Safety Defect and Noncompliance Report Guide for Vehicles
PART 573 Defect and Noncompliance Report

07V-174
(9 pages)

On or about January 2, 2007, RELIANCE TRAILER CO., LLC decided that a defect which relates to motor vehicle safety exists in the motor vehicles listed below, and is furnishing notification to the National Highway Traffic Safety Administration in accordance with **49 CFR Part 573 Defect and Noncompliance Reports**.

Reliance Trailers has determined that a defect which relates to motor vehicle safety exists in some of our transfer trailer chassis'. The drawbar hinge assemblies at the front of the turntable may have been either incorrectly assembled or improperly tightened during assembly. One or both of these conditions may exist with your Reliance transfer trailer chassis.

TIGHTENING PROCEDURES FOR RELIANCE DRAWBAR HINGE ASSEMBLIES

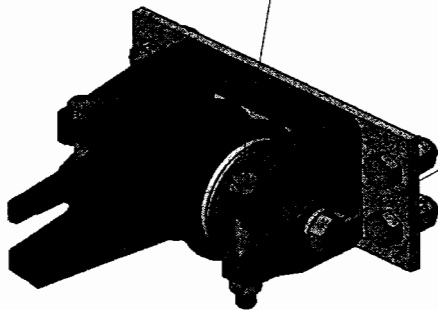
Insure that the **correct bolts*** with lockwasher are started in each tapered hinge pin of the drawbar hinge assembly. Loosen the 1/2" X 4" vertical bolt assembly adjacent to each

3/4" bolt. Alternately tighten each 3/4" bolt to **120 ft-lbs of torque**, assuring that

drawbar housings at end of drawbar remain centered in hinge castings at front of trailer.

Test springs for desired rotational stiffness. If a stiffer hinge is desired, tighten 3/4" bolts in

10 to 20ft-lb increments. **DO NOT EXCEED 160 ft-lbs of torque.** Once tightened to the

desired stiffness, there should be equal protrusions of bushing on both sides of the drawbar

housings. Retighten the 1/2" X 4" bolts that were previously loosened.

* **3/4" x 3", USS, Grade 8, full thread bolt**

DRAWBAR HINGE BOLTS

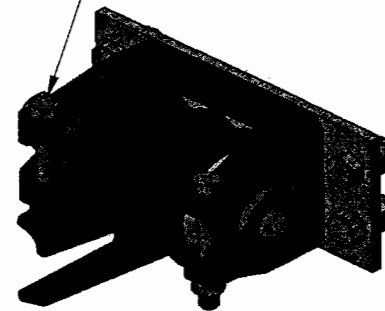
INCORRECT

SHOULDER STYLE BOLT

CORRECT

FULL THREAD STYLE

INSPECT THIS BOLT ON
BOTH ASSEMBLIES

LOOSEN THIS BOLT AS PER
TIGHTENING PROCEDURE

INSPECT DRAWBAR HINGE ASSEMBLY TO ENSURE RETAINER BOLTS ARE 3/4" X 3" GRADE 8 **FULL THREAD** BOLTS. IF BOLTS HAVE SHOULDER AS SHOWN IN DETAIL, REPLACE WITH FULL THREAD STYLE, AND REPLACE 3/4" LOCK WASHER. SEE PAGE TWO OF THIS DRAWING FOR BOLT TIGHTENING PROCEDURE
